**PLAN COMMISSION / ZONING BOARD OF APPEALS
AGENDA**

Project: Plantz Residence – 213 Nebraska Street
Meeting Type: Public Hearing
Request: Variations (8)
Location: 213 Nebraska Street
Applicant: Ronald Plantz
Prop. Owner: Ronald Plantz
Representative: Gabriel Garcia c/o Ideal Custom Designs, Inc.

213 Nebraska Street - Plantz Renovation

Proposed Home – Requested Variations:

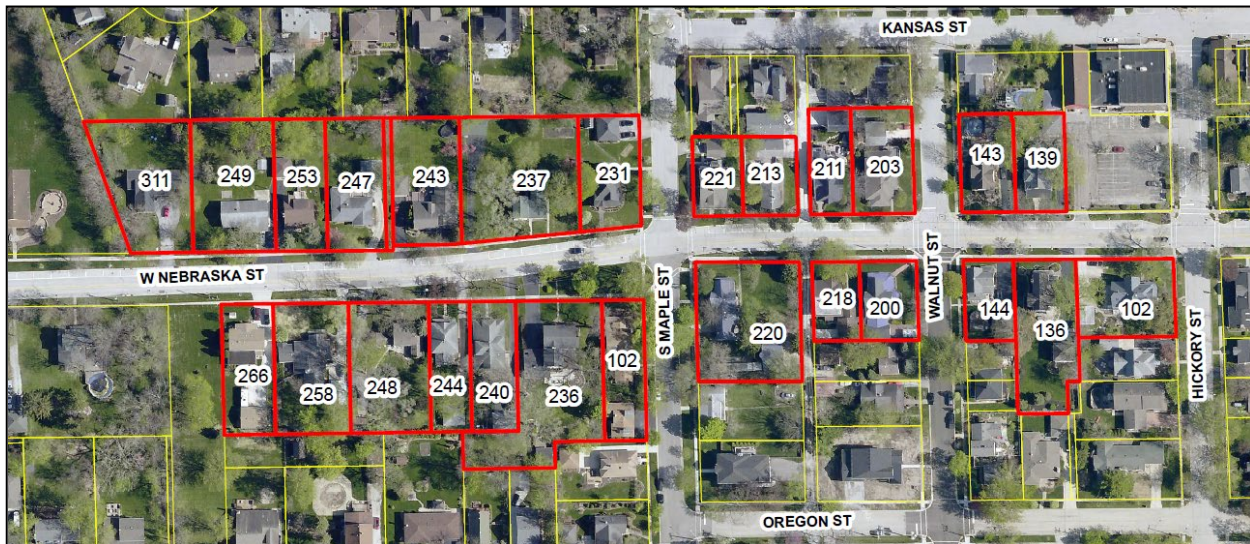
In consideration of the variation requests, staff offers the following points of discussion:

SITE PLAN

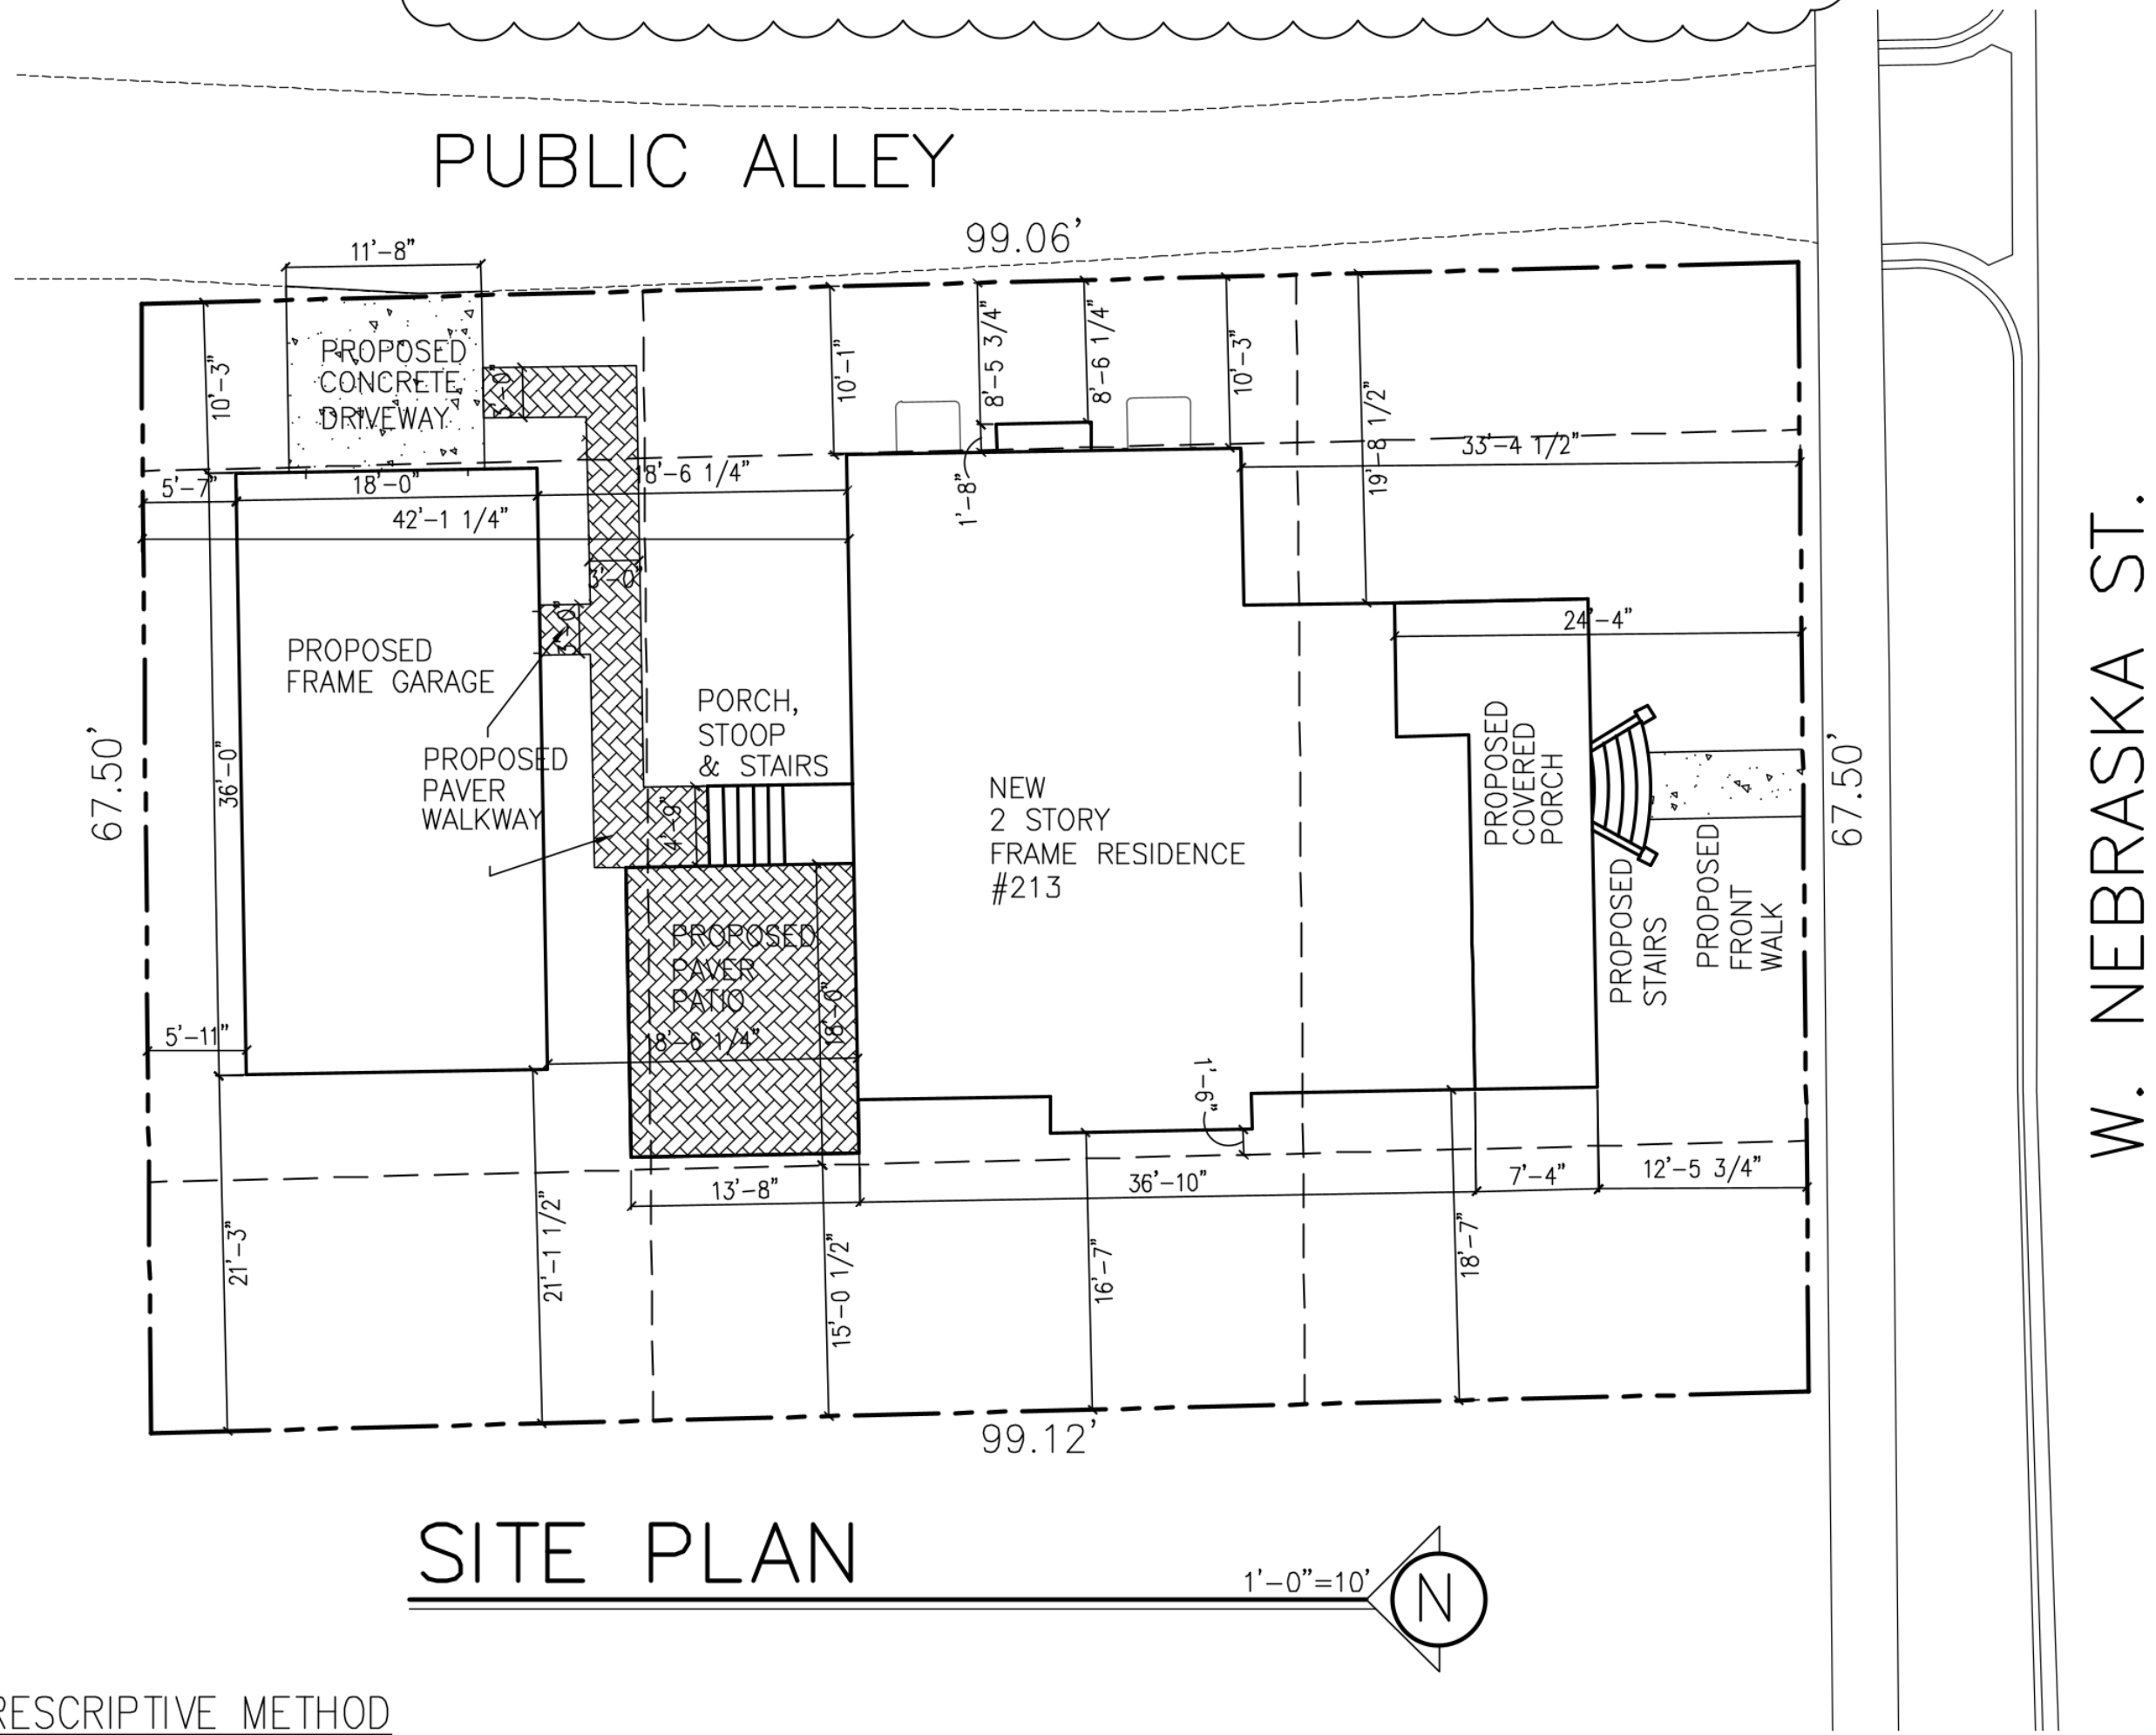
- a) The proposed accessory building (detached garage) would be located in approximately the same place as the former detached garage, although it would be moved closer to the public alley. Detached garages must be set back at least 10' from side and rear property lines. Per the Existing Conditions, Removal and Erosion Control Plan, the former garage was set back 6.2' from the north (rear) property line and 19' from the east (side) property line. As such, the former garage was considered existing, non-conforming regarding the rear yard setback.

3. Recommend the Village Board approve the variation request to permit a 5' 7" rear yard setback for an accessory structure instead of 10', on the property located at 213 Nebraska Street, in accordance with the reviewed plans and public testimony.

5. Recommend the Village Board approve the variation request to permit a lot coverage of 32.8%, instead of 20%, on the property located at 213 Nebraska Street, in accordance with the reviewed plans and public testimony.

6. Recommend the Village Board approve the variation request to permit an impervious lot coverage of 41.9%, instead of 40%, on the property located at 213 Nebraska Street, in accordance with the reviewed plans and public testimony.

Commissioner Schaeffer stated her largest concern was with the impervious lot coverage. The backyard of the property was relatively small. She stated that the site plan showed a wood deck on the rear of the building. She asked if wood was considered an impervious surface.

Commissioner James noted that it appeared on the proposed plans, the rear deck would be smaller.
